MEMORANDUM

TO:	Historic District Commission City of Saugatuck
FROM:	Grayson Moore Director of Planning & Zoning
MEETING DATE:	August 6, 2026
RE:	Historic District Permit Application, 249 Mason Street

REQUEST:
The applicant is requesting retroactive approval for the installation of a fence enclosing the approved outdoor amenity area located within the former bank drive-thru lane and covered service area. The fence varies in height from 48 inches (4 feet) to 67 inches (5.58 feet) and is constructed of pine intended to weather to a soft gray patina.

Figure 2: PC Application 4/2025

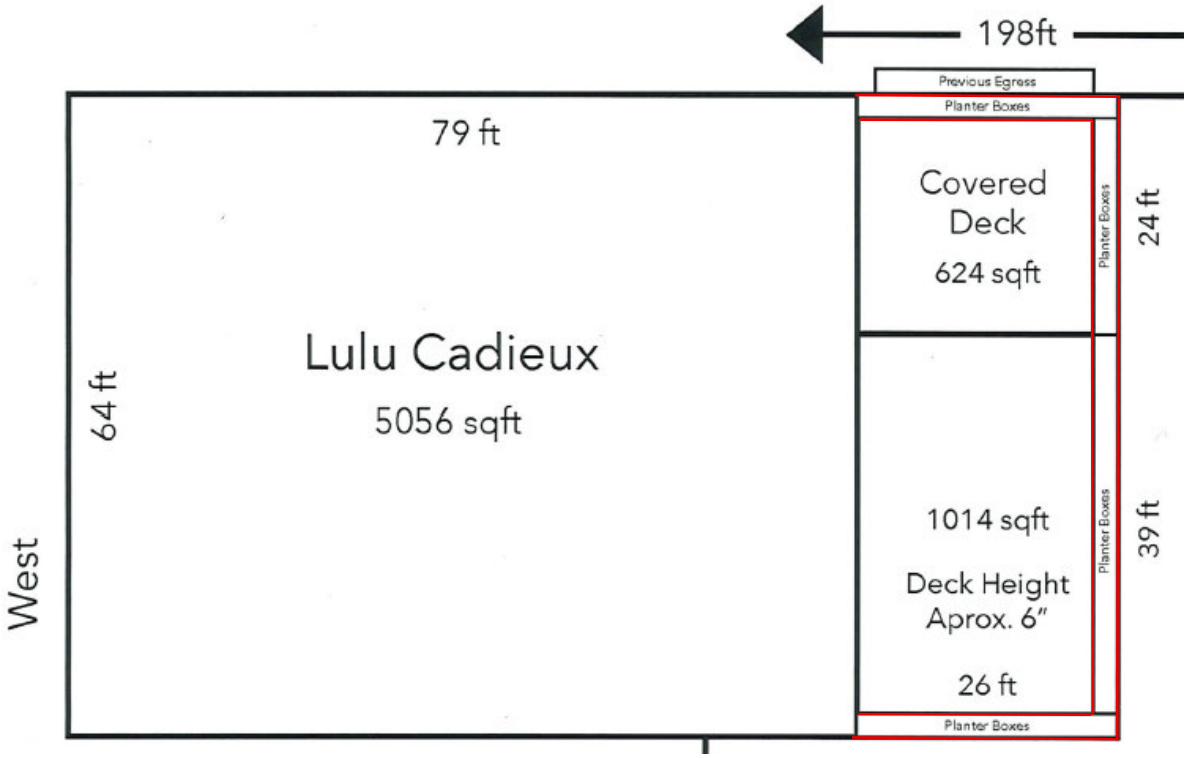
At its June 19, 2025 meeting, the property received Planning Commission approval for the conversion of the existing drive-thru lane and covered service area with outdoor amenity space. Approved plans have been attached for reference which did not identify the installation of fencing. This application noted planter boxes being placed around the entirety of the deck (outlined in red). No further detail was provided.

DECK PLAN
SCALE: 1/4" = 1'-0"

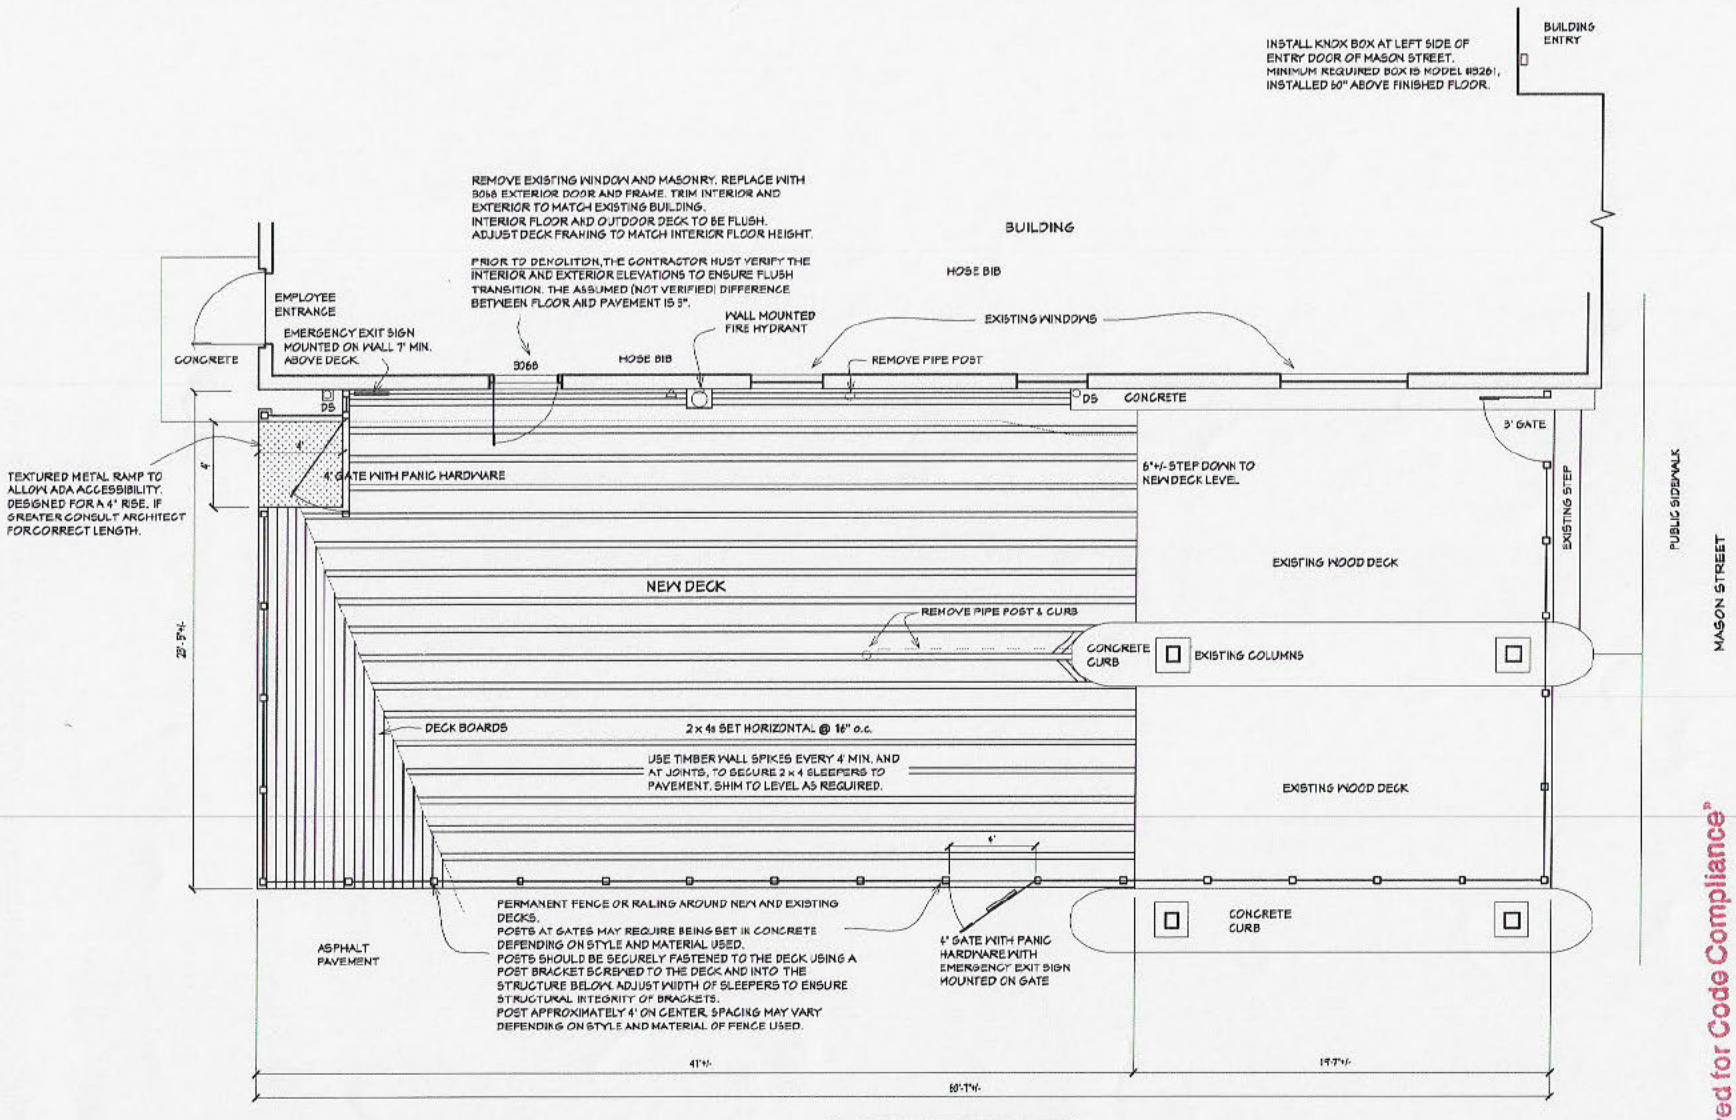
We are in receipt of the building plan for the LuLu Cadieux Deck Expansion received 4/3/2026. We reviewed the plans using the International Fire Code (IFC) 2015 edition. Please see the result of the fire department review listed ***below***.

5. The size and distribution of portable fire extinguishers shall be in accordance with Sections 906.3.1 through 906.3.4. ***Approved, extinguisher is shown on the plans.***

8. Doors serving a Group H occupancy and doors serving rooms or spaces with an *occupant load* of 50 or more in a Group A or E occupancy shall not be provided with a latch or lock other than *panic hardware* or *fire exit hardware*. (IFC 1010.10.10) ***Panic hardware is shown on the plan.***

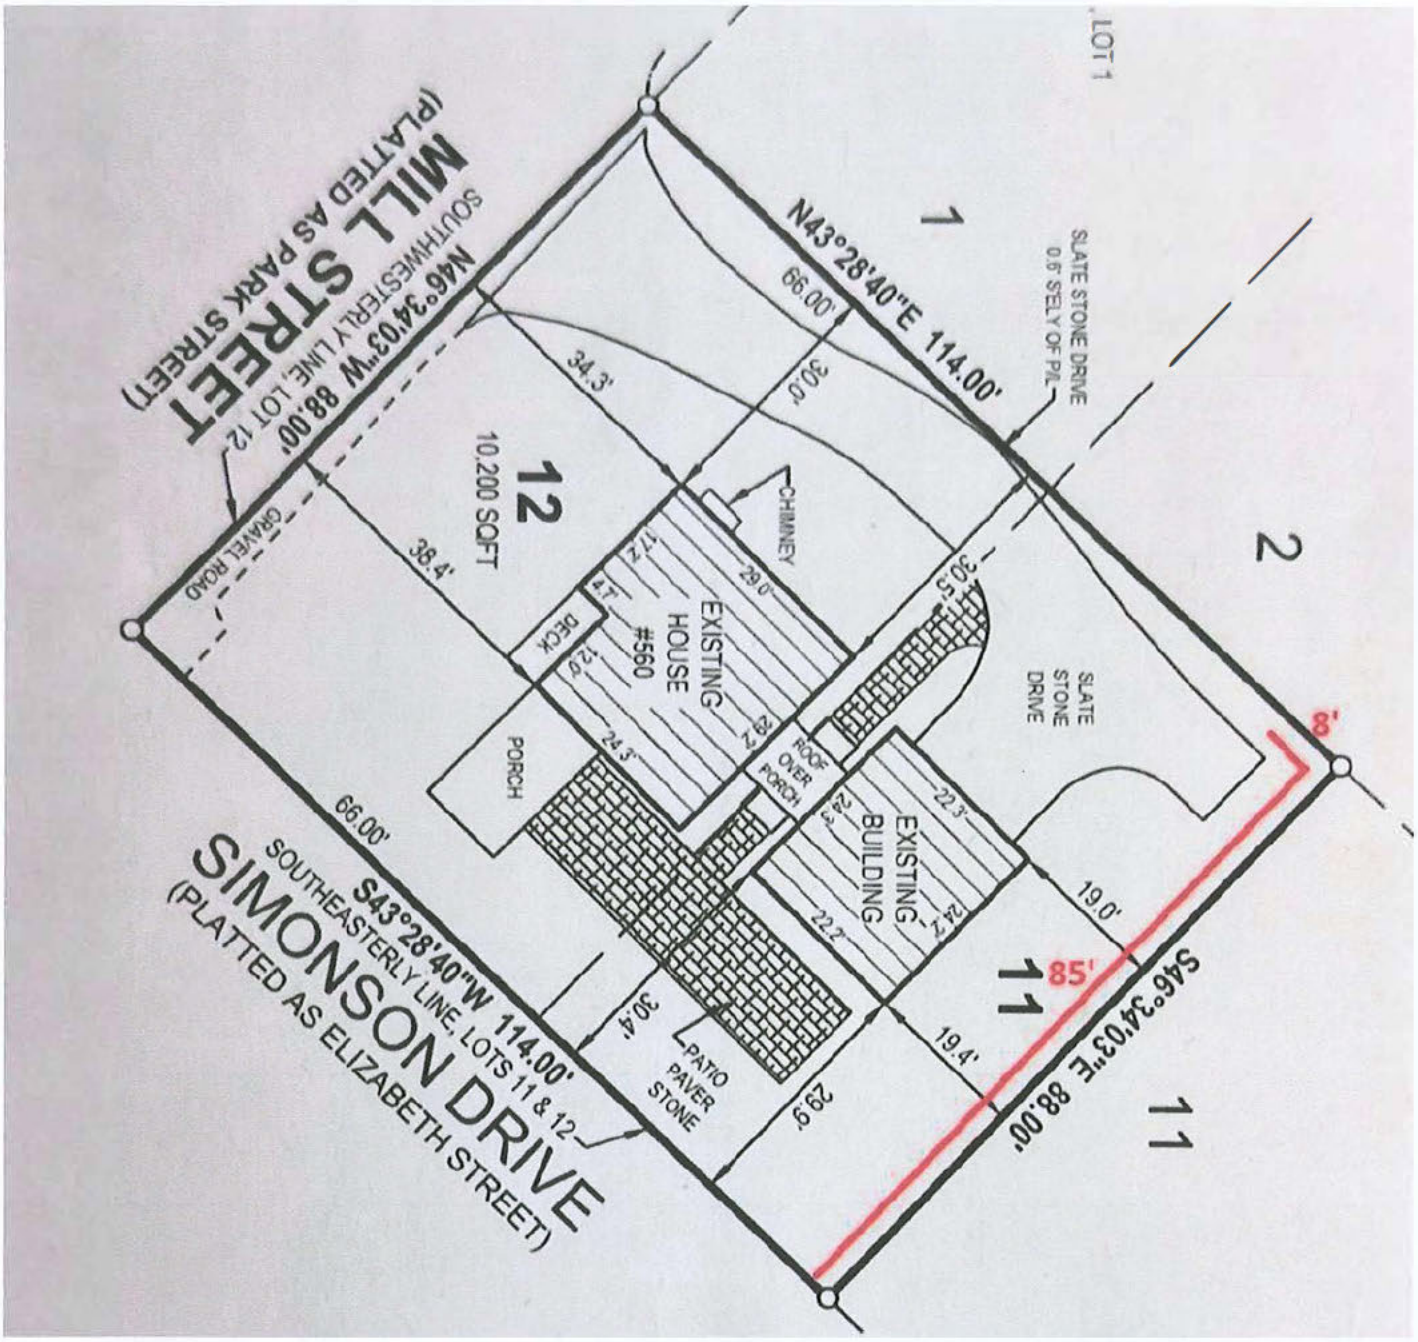
From foundation to street fence must not exceed 3 feet. Shown in blue
